গণপ্রজাতন্ত্রী বাংলাদেশ সরকার  
শ্রম ও কর্মসংস্থান মন্ত্রণালয়  
কলকারখানা ও প্রতিষ্ঠান পরিদর্শন অধিদপ্তর

ক্যাপ পর্যবেক্ষণের তথ্য

কারখানার নাম	কতুল্লা এম্পাওয়ারেলস লিমিটেড
ঠিকানা	B-68/1 Wapda Road, Jalkuri, Siddirganj, Narayanganj
কারখানার কোড	NRY087
কালার কোড	
মূল্যায়নের ধরণ: <a href="#">কাঠামোগত মূল্যায়ন</a>	পর্যবেক্ষণের তারিখ: ০১-০২-২০২৩
১. পর্যবেক্ষণ

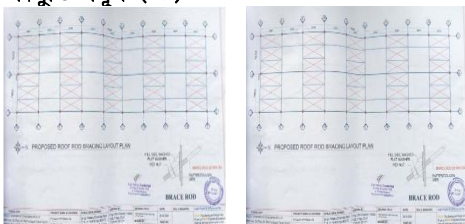
পরিদর্শন পর্ববেষ্টিত	During inspection, bracing for lateral stability in 1st and GF was not found.
ক্যাপ আইটেম ক্যাটাগরি

কার্যক্রম	Verify the lateral stability of the structure and confirm the requirement of any bracing of the structure.
সুপারিশের তথ্যসূত্র	
কারখানার কার্যক্রম	We have already engaged consultant to verify lateral stability of the structure to confirm the requirement of any bracing of the structure.
অগ্রাধিকার	৬ সপ্তাহ
চূড়ান্ত সময়সীমা	১৫-০৯-২০১৬
সংশোধিত সময়সীমা	০১-০১-১৯৭০
অগ্রগতির অবস্থা	চলমান
মন্তব্য	27-10-2020, They have already talk to their consultant engineer to verify lateral stability of the structure. 13.01.2021-During inspection, bracing for lateral stability in 1st and GF was not found. But they have already talk to their consultant engineer to verify lateral stability of the structure. 03-06-2021 ( CVV4 ) : During inspection, bracing for lateral stability in 1st and GF was not found. But they have already talk to their consultant engineer to verify lateral stability of the structure but not yet. 24-Aug-2021 ( CVV5 ) : As-built architectural drawing, structural drawing & DEA report have been prepared and submitted to DIFE for approval ,only submission letter of that is available. 28-Aug-2022: After Submission of DEA report DIFE have some correction. Factory management says that, they has been start to work this correction & Corrected DEA report will submit to DIFE as soon as possible. Proposed Bracing layout plan & sectional drawing found on site during visit. 01-Feb-2023: After Submission of DEA report DIFE have some correction. Factory management says that, they has been start to work this correction & Corrected DEA report will submit to DIFE as soon as possible.
